# Access Compliance Report

## Public Rights-of-Way

| Intersection ID: 4147                   | Main Street: DAVIS_LAKE_PY | Cross Street: SAGEWOOD_PL               | Location: NE           |
| ADA ID: 34F876363544                    | Ramp Type: Perp            | Initial Pass/Fail: Fail                 | Overall Compliance: No |

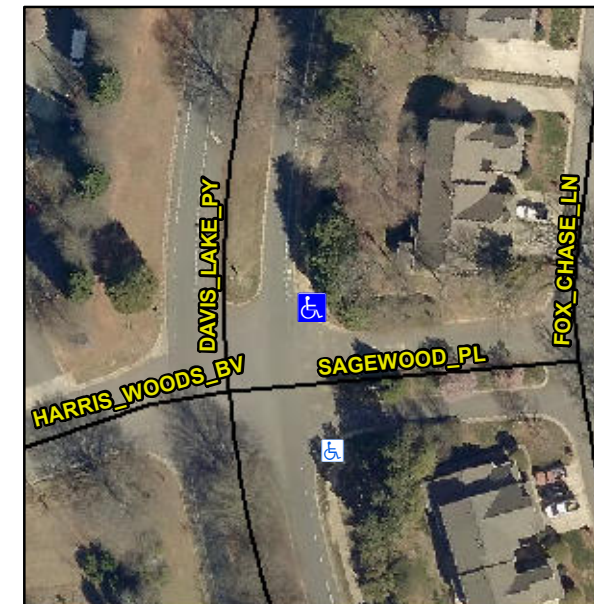
**R304.2.2, R304.5.3**

| Compliance | Description           | Data | Compliance | Description                 | Data |
|------------|-----------------------|------|------------|-----------------------------|------|
| N/A        | Ramp Length (in)      | 48.0 | No         | Ramp Slope (%)              | 20.0 |
| Yes        | Ramp Width (in)       | 51.0 | No         | Ramp XSlope (%)             | 10.0 |

**Remove & Replace Entire Ramp.**
